## Summary of SciFi electronics review

## Electronic Review (held on the December 11, 2013)

*Reviewers* : Federico Alessio (CERN), Luciano Musa (CERN), Jose Francisco Toledo (University Valencia), Ken Wyllie (CERN)

Figure : PACIFIC design

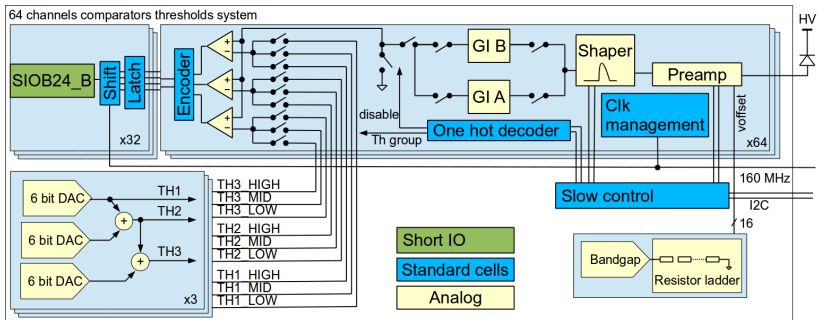
- ▶ The PACIFIC design is advancing well
- ▶ A complete set of specifications is missing and should be compiled immediately
- ▶ The preparation for testing should be carefully planned and scheduled, and manpower identified
- ▶ The precise bias circuit that will be used for the SiPMs was not shown in the meeting and is not described in the documentation
- ▶ The precise bias circuit that will be used for the SiPMs was not shown in the meeting and is not described in the documentation
- ▶ we propose that the SiPM short-circuit failure mode is taken into account in the design
- ▶ The sensitivity of the PACIFIC design to power supply noise (power-supply-rejection ratio) should be carefully simulated
- ▶ The electrical characteristics of the flex cable between PACIFIC and the SiPM should be extracted and included in the model used for simulating the front-end

All the choices have been made:

- ▶ Fast shaping with gated integrators
- ▶ 2 bit non-linear digitization scheme
- ▶ Common thresholds/64 channels
- ▶ Per channel voltage control

Figure : Possible front-end board design (*Magali and Wilco*)

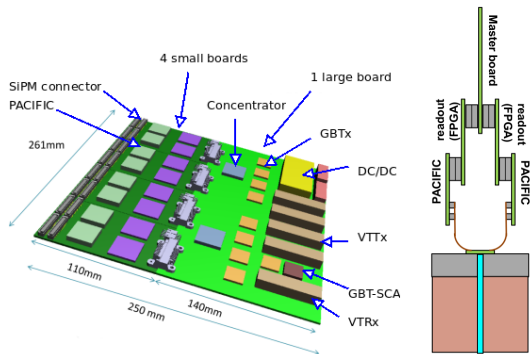
- ▶ The modularity of the FEB should be rationalised (PACIFIC and clustering FPGA on different PCB)
- ▶ The use of commercial-off-the-shelf components in the FEBs must be assessed carefully together with the expected radiation levels in the environment

- ▶ single-ended I/O may require SSTL signaling due to the high data rate (128ch x 6 bit x 40 MHz makes approximately 30 Gb/s). Simultaneous switching noise may become a concern. Alternatively, LVDS or other gigabit-per-second differential standards may reduce the switching noise but also increase the I/O count

- ▶ A point-of-load power distribution approach would be advisable and so extra board area should be considered for the small readout board
- ▶ The general power and grounding scheme of the FEB should be studied, including the different possibilities for local regulation
